66 Fitzjohn's Avenue,
London, NW1 0AA

Basement Impact Assessment
Audit

London Borough of Camden

Project Number: 12066-98
Revision: D2

DRAWING NUMBER 15094/SK02revA BY MICHAEL CHESTER & PARTNERS

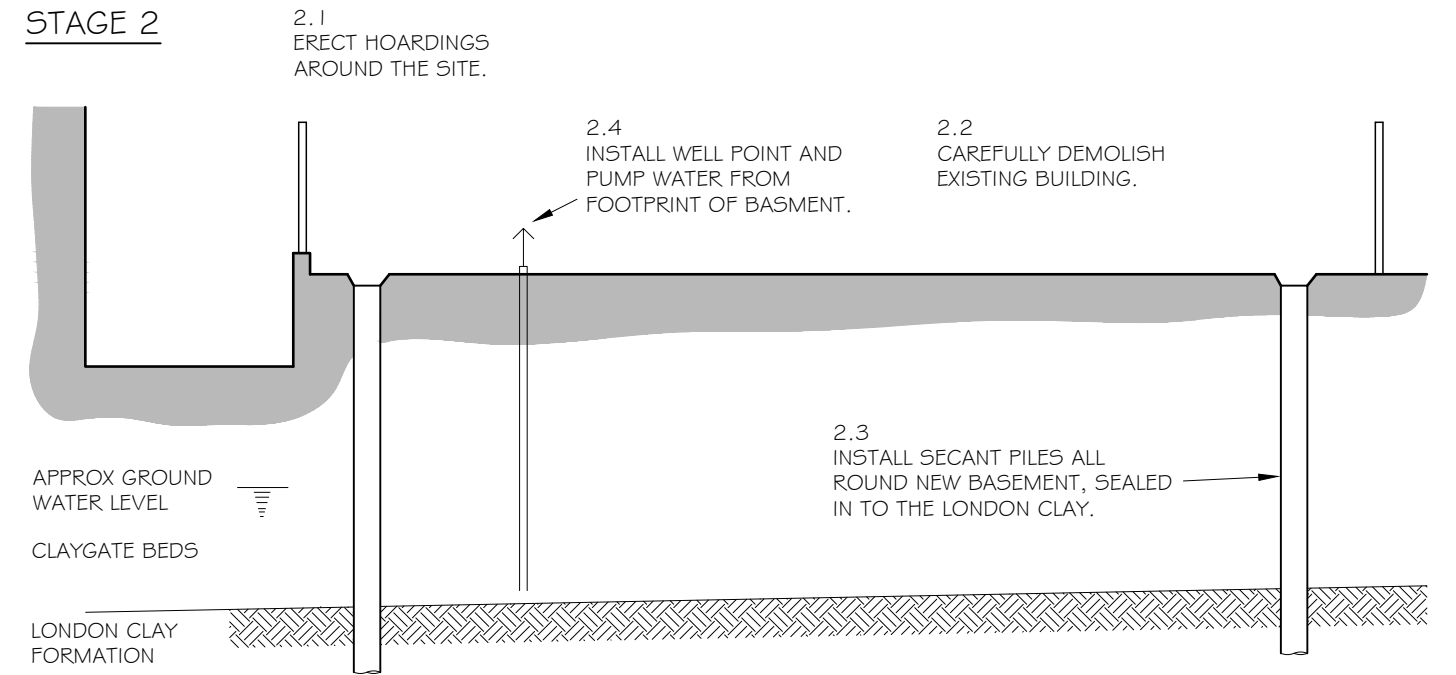
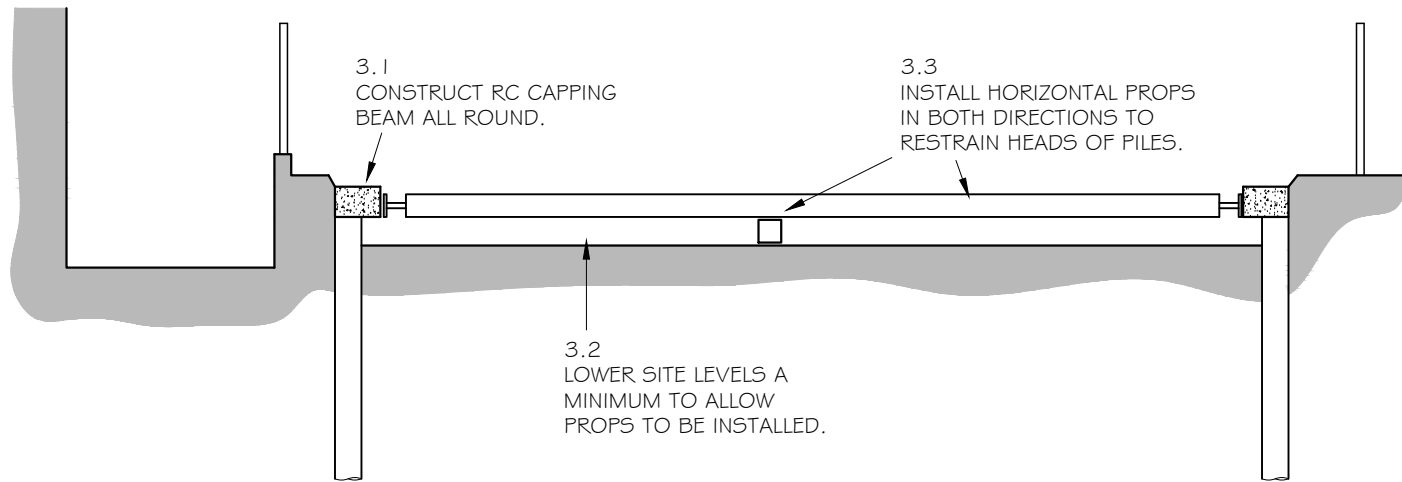
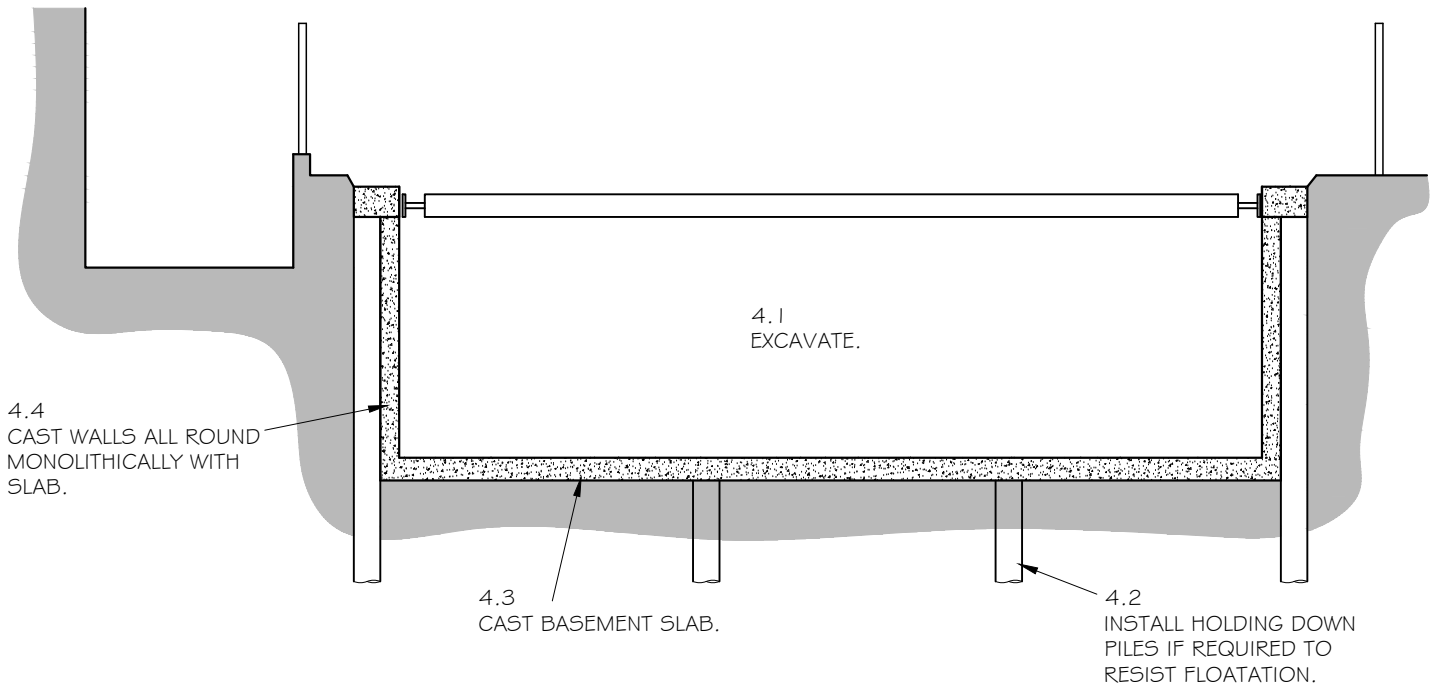
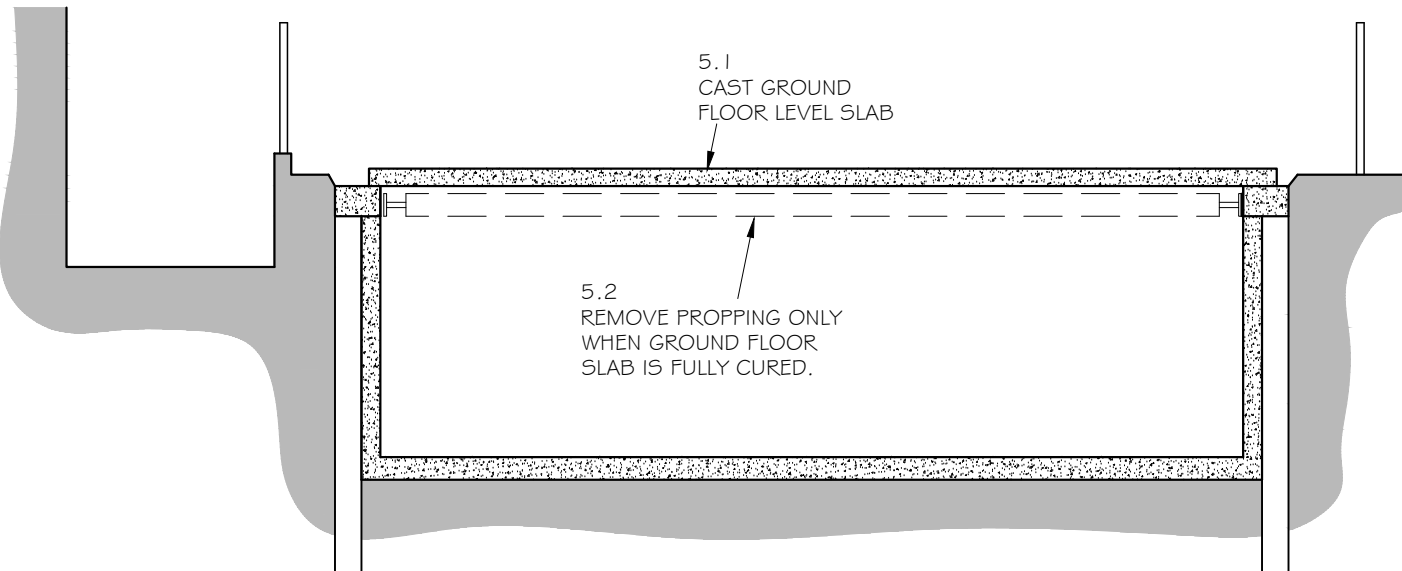
- cast walls;
 - cast ground floor slab; and
 - remove upper props.
- 4.14. Indicative calculations and a basic sequence of construction have been provided. It is noted that the soil stiffness adopted in the retaining wall design are higher than those normally assumed in these circumstances and differ from those adopted in the accompanying ground movement assessment. This should be resolved in detailed design and agreed with the party wall surveyor.

Drawing number 15094/SK02revA by MCP (Appendix D) and pile calculations by Southern Geotechnical Design Ltd (Appendix B) describe the sequence of construction and principles of the design and propping. In summary this is as follows –

- a) Erect a hoarding around the site and demolish the existing building.
- b) Install a secant piled wall around the perimeter of the proposed basement, sealed in to the London Clay.
- c) Pump ground water out from within the footprint of the proposed basement.
- d) Construct a capping beam to tie the heads of the piles and install horizontal props to restrain the head of the piled wall.
- e) Excavate within the piles to new basement level. Cast new basement slab and the new permanent retaining walls all round the excavation.
- f) Cast the ground floor level slab.
- g) Remove temporary props when ground floor level slab is fully cured.
- h) Complete construction of superstructure.

Figure 1: Sketch plan of site

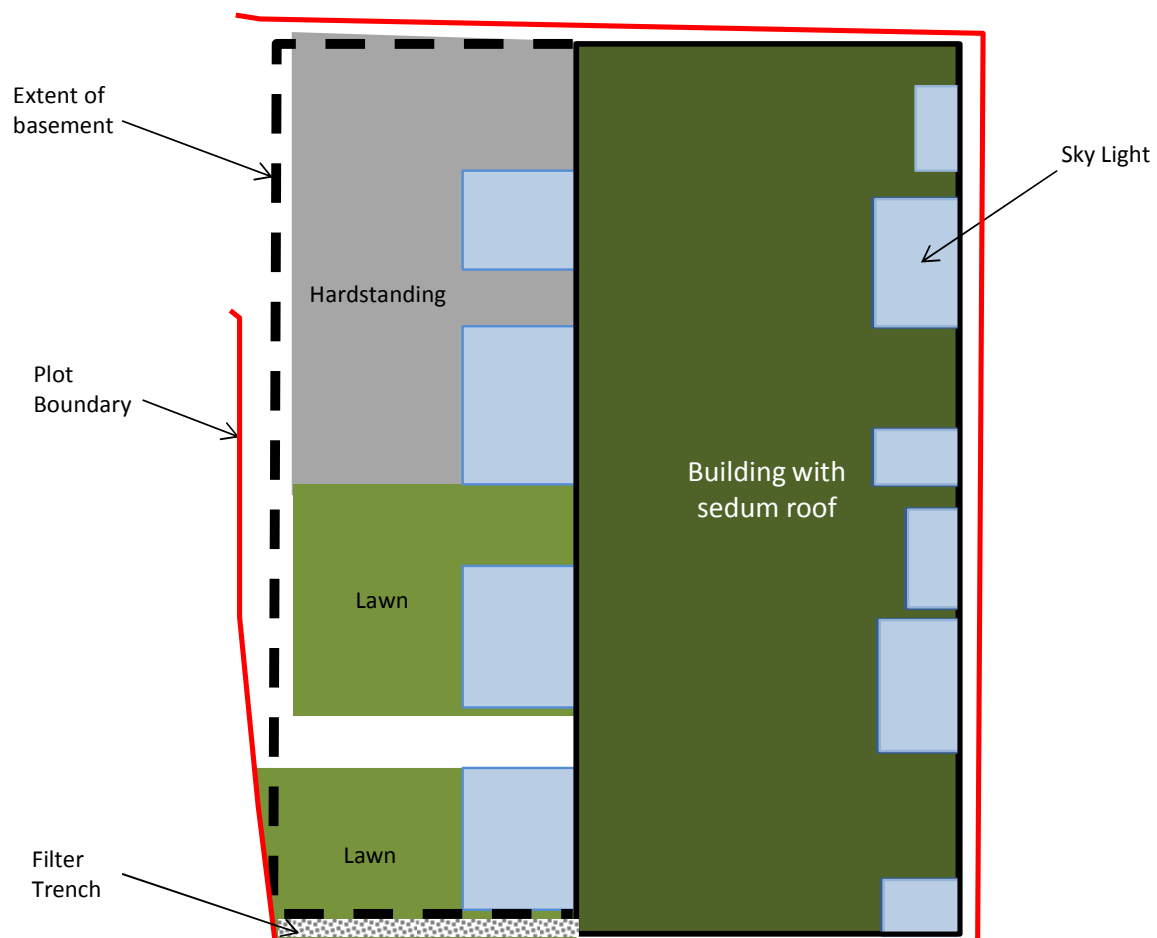
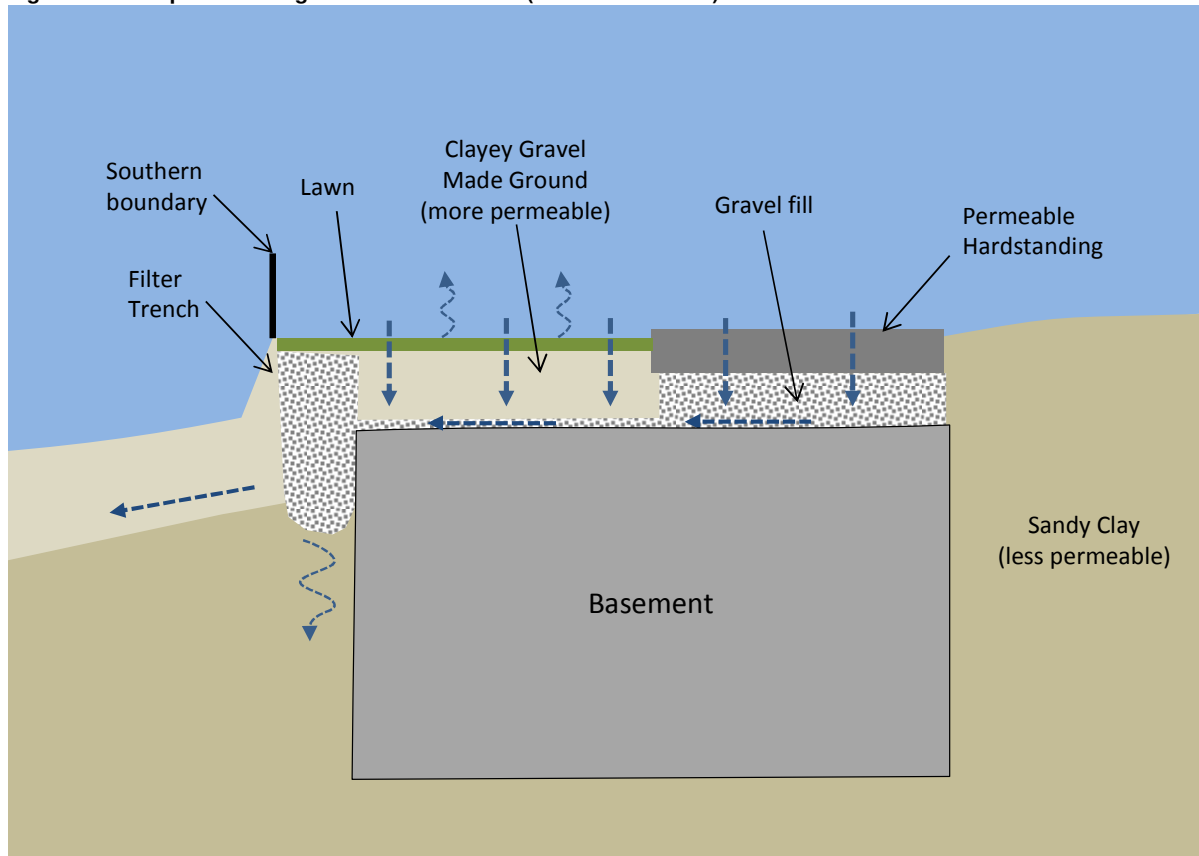
- 1.17. The proposed development increases the impermeable surface area. Supplementary information provides justification for proposed mitigation measures.

Post-development, runoff from the area of hardstanding (and skylights), to the west of the building, would be directed towards the lawn. These flows, and rainfall falling directly on the lawn, would (less any losses resulting from evaporation) infiltrate down towards the underlying basement. Prior to reaching the impermeable roof of the basement, flows would drain due south within a shallow sub base drainage layer to be installed above the basement. The presence of a grassed filter strip at the southern extent of the basement (see Figure 1) and very shallow gradient sloping down to the south along the roof of the basement would help ensure that this water drains southwards and does not pond above the basement. The precise approach will be confirmed at the detailed design stage.

The passive infiltration would occur to the south of the basement where it would not impact upon the neighbours' sunken patios (located to the west). The suggestion that attenuation storage might be provided relates to the possible need to store excess water during severe storms prior to it either infiltrating into the deeper sandy clay (at a slow rate) or progressing laterally downslope within the shallower more permeable layer. The requirement for such attenuation storage and its sizing would be dependent upon infiltration rates. Further review and, if necessary, detail design of any necessary features would be carried out after the planning application is granted, when infiltration testing is recommended to confirm potential infiltration rates.

- construction of the hardstanding area above the north of the basement with permeable material (i.e. open structure bricks or similar) set above gravel. Assuming a hardstanding formation depth of 0.2 m (probably thicker than necessary) the gravel bed would be at least 0.1 m thick. Rainwater falling on the hardstanding would percolate through and would be slowed and stored within the void spaces prior to discharging to the south. Based on a hardstanding area of 48.4m², a 0.2m deep layer of gravel and a void ratio of 0.3, this would provide 1.5m³ of additional storage to hold and attenuate flows prior to discharge.

- a grassed filter drain constructed parallel to the southern edge of the western part of the basement. This would provide additional storage required to hold and attenuate flows and would also assist in recharge of groundwater via infiltration. Conceptually, a 0.5m wide, 5m long trench that extends from the surface down to 0.5m below the top of the basement could be created (i.e. 0.9m overall depth). If this was filled with coarse gravel it would provide an additional 0.7m³ of storage.
